**PLANNING APPROVAL,
PLANNED UNIT DEVELOPMENT &
SUBDIVISION STAFF REPORT****Date: September 18, 2014**

<u>NAME</u>	Smith Memorial AME Church
<u>SUBDIVISION NAME</u>	Smith Memorial AME Church
<u>LOCATION</u>	6501 Felhorn Road North (Southwest corner of Felhorn Road North and Roslyn Drive West)
<u>CITY COUNCIL DISTRICT</u>	District 4
<u>PRESENT ZONING</u>	R-1, Single-Family Residential District
<u>AREA OF PROPERTY</u>	1 Lot / 1.0± Acre
<u>CONTEMPLATED USE</u>	Planning Approval to allow the expansion of an existing church in an R-1, Single-Family Residential District, Planned Unit Development approval to allow a reduced side yard setback, and Subdivision approval to create one legal lot of record.
<u>TIME SCHEDULE FOR DEVELOPMENT</u>	None given..

PROPOSED SITE PLAN

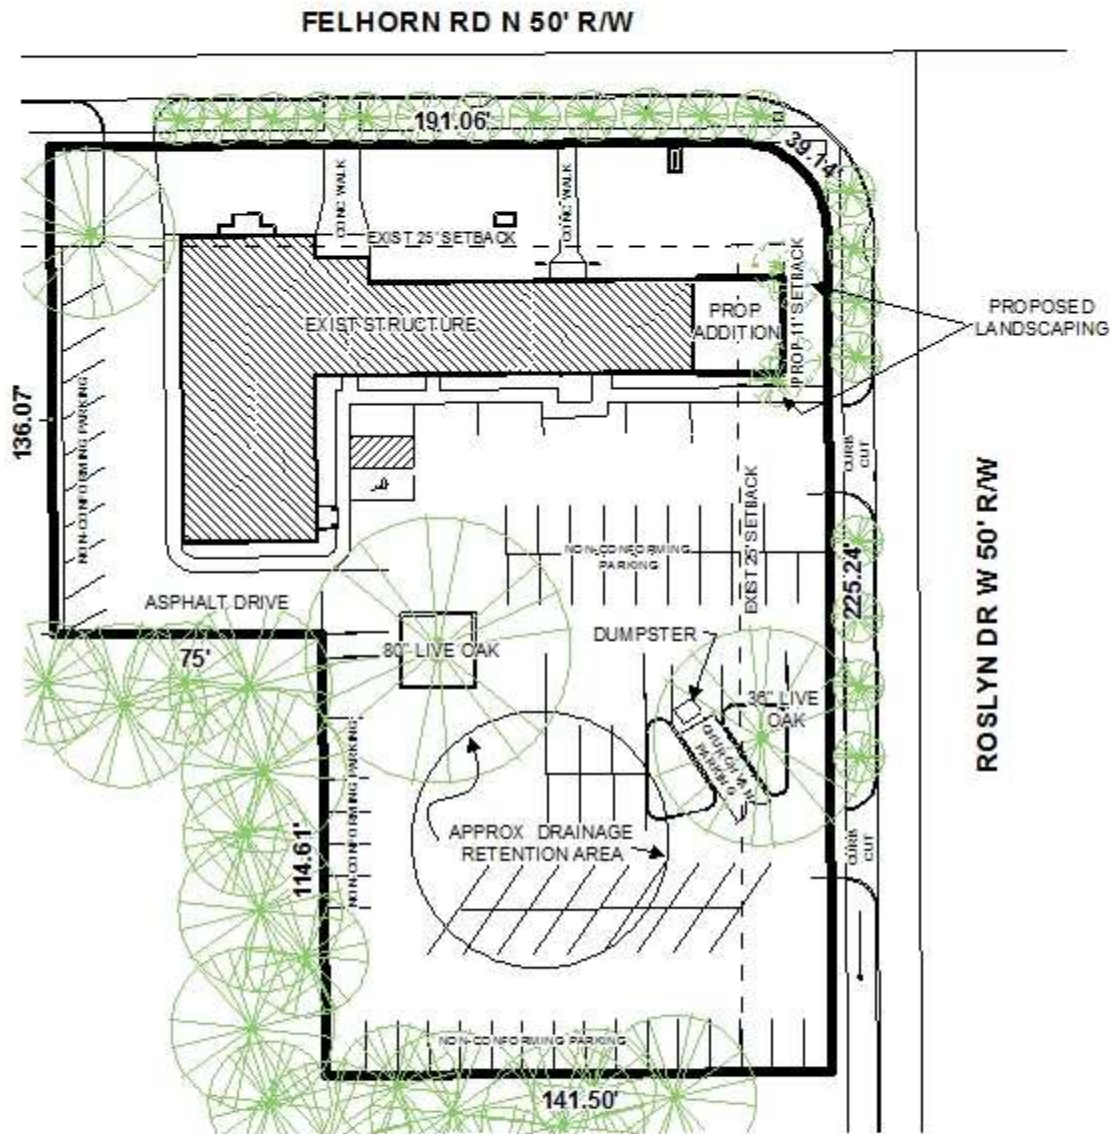
Most of the discrepancies between the survey and the site plans have been cleared, most importantly relating to the actual location of the existing building on the site and the proposed kitchen addition. However, it should be noted that on the Planning Approval and PUD site plans, the location of the building has not been adjusted to scale, and the revised dimensions are noted as not being to scale.

The kitchen addition is proposed to be 11'-0" off the East property line along Roslyn Avenue, and would contain approximately 660 square feet. The end of the building where the addition is proposed is currently 36' off the Roslyn Avenue property line and, if maintaining the required 25' setback off Roslyn Avenue, only an 11' extension would be allowed. That would mean that, in order to have the 660 square feet proposed, the addition would have to be 60' long stretching North and South. As the existing building is only about 3' from the parking lot sidewalk to the South, the major part of the addition would have to extend to the North toward Felhorn Road North and come within approximately 5' of the front property line, creating a much greater setback encroachment than proposed along Roslyn Avenue. To build to the South of the existing building would be impracticable due to the existing nonconforming parking lot and would diminish the already insufficient number of parking spaces.

It should be noted that the stated sanctuary seating was 204 in the 1994 Planning Approval, and the site plan was approved for 39 on-site parking spaces, with 20 spaces in the proposed off-site parking area. The unapproved expanded parking area provides approximately 34 spaces. But the seating capacity is now stated to be 400 persons which would require 100 on-site parking spaces. As 75 are provided, the applicant requests relief from the required 100 on-site parking spaces. As many of those provided are noncompliant in size and there are three large Live Oak trees (60", 40" and 36") within the parking lot, the re-configuration of the parking area and traffic flow to compliant standards could be impracticable; however, the previous sanctuary expansion was based upon the provision of compliant parking areas. As per the Traffic Engineering comments, if the parking lot is resurfaced in the future, the parking lot layout should be reconfigured to provide as many conforming parking spaces as possible on this site. It should be noted that the Subdivision plat indicates the three trees, but the site plans omit the 40" Live Oak tree.

There is a discrepancy between the site plans and the Subdivision plat as to the size of the largest Live Oak tree located within the rear parking area. The site plans indicate 80" in diameter while the plat indicates 60" in diameter. The size should be verified and revised on whichever is erroneous. Regardless, no perimeter tree plantings would be required since sufficient tree credits are present even if this tree is 60" in diameter along with the 40" Live Oak in the rear parking area shown on the survey. No parking understory trees are indicated, and four would be required. However, once the size of the Live Oak tree in question is determined, this may count as some credit toward the parking tree requirement. If not, parking trees should be coordinated with Urban Forestry.

A discrepancy exists between the Subdivision plat and the site plans with regard to the paved area along the South and West portions of the parking area. The survey indicates an encroachment onto the adjacent properties but this is not indicated on the site plans. Verification should be submitted prior to signing the Final Plat that this encroachment has been corrected.

- 1) revision of the site plan to locate the building to scale to match the Subdivision plat;
- 2) revision of the site plan to show stormwater detention facilities for all impervious areas added since 1984;

- 4) *verification that the 400-person seating capacity is compliant with the Building and Fire code requirements;*
- 5) *revision of the site plan to show the 40" Live Oak tree within the parking area as indicated on the Subdivision plat;*

- 6) *verification and revision of, if necessary, the size of the Live Oak tree on the Western portion of the main parking area (60" or 80");*
- 7) *revision of the site plan to provide bumper stops in the nose-in parking stalls along the perimeter where there is adjoining residential property;*

- 1) revision of the site plan to locate the building to scale to match the Subdivision plat;*
- 2) revision of the site plan to show stormwater detention facilities for all impervious areas added since 1984;*

- 4) verification that the 400-person seating capacity is compliant with the Building and Fire code requirements;*
- 5) revision of the site plan to show the 40" Live Oak tree within the parking area as indicated on the Subdivision plat;*

- 6) verification and revision of, if necessary, the size of the Live Oak tree on the Western portion of the main parking area (60" or 80");*
- 7) revision of the site plan to provide bumper stops in the nose-in parking stalls along the perimeter where there is adjoining residential property;*
